**TOWN OF FAIRFAX
STAFF REPORT**
Department of Planning and Building Services

TO: Fairfax Planning Commission
DATE: October 17, 2024
FROM: Kara Spencer, Associate Planner
LOCATION: 58 Ridge Road; APN: 001-061-27
ZONING: RS-6 Single-Family Residential Zone
PROJECT: Expansion, remodel, and partial roof modification of a single-family residence
ACTION: Conditional Use Permit (CUP); Application No. 24-13
APPLICANT: Laura Kehrlein
OWNER: Erica Smith
CEQA STATUS: Categorically exempt, §§ 15301(a) and (e)(1)

58 RIDGE ROAD

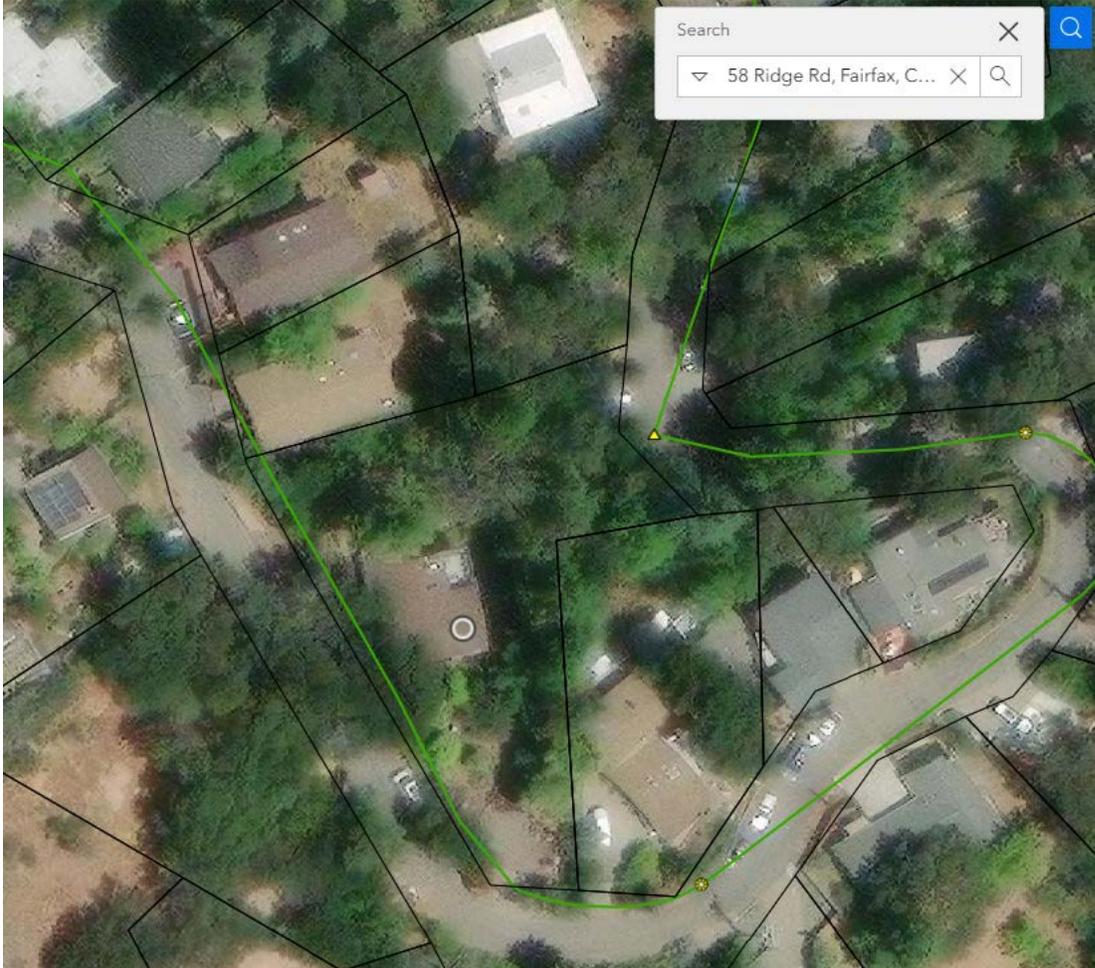
Many of our easements are prescriptive in nature, and we do not keep copies of easement recordings. Typically, our easements are 10 feet wide, centered over the pipe.

We have illustrative maps that show the general vicinity of our infrastructure; however, the contractor is responsible for field location. Our illustrative maps can be utilized by searching an address [here](#).

Below is an image showing our infrastructure in green:

The Town and the applicant do not have any records that indicate the location of the pipe or easement. Do you have a specific document that identifies the sewer line and easement on the property?
